Modifications complete set:

Modifications

Control board 020.204

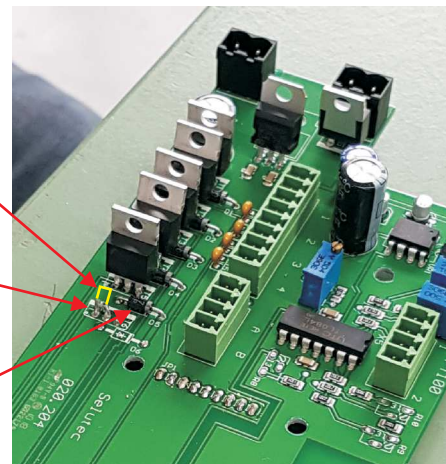
Step 1:

- T6 remove
 - D6 remove
 - Solder bridge Pin 1 + 2
- please see additional video

Solder bridge

Mosfet T6

Diode D6

Step 2:

Terminal block to C18

Step 3:

Connecting cable
